# Comments on CEC Revised 2010-2020 CED Forecast

CEC Workshop – September 21, 2009

Richard Aslin – Pacific Gas and Electric Company

**09-IEP-1C**

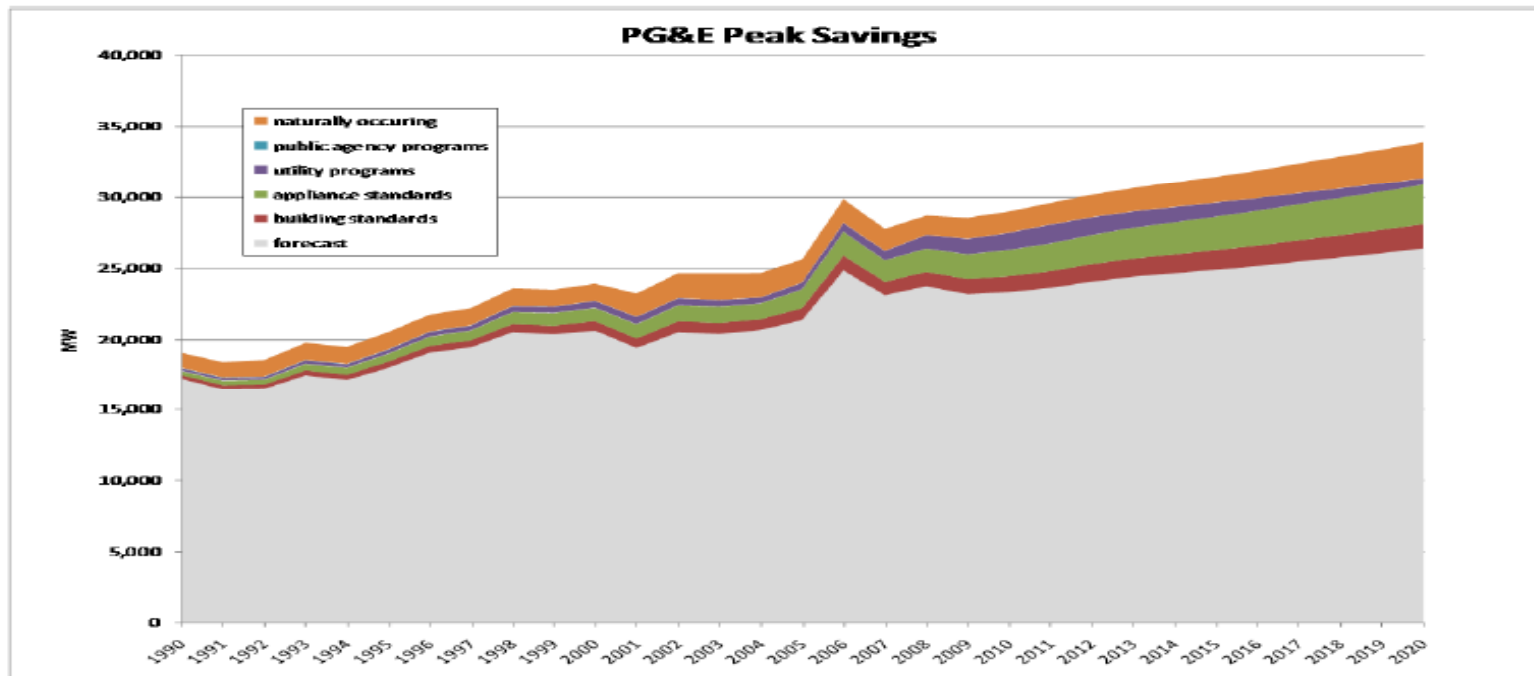
In many years in the history the “year-over-year” total EE peak savings are significantly negative. Does that make sense?

Total savings 28% of forecast by 2020

- **The modeling of the embedded CEE needs further work. There should be an underlying assumption that consumers, on average, replace upgraded equipment/appliances with equally efficient equipment/appliances at the end of their useful lives.**
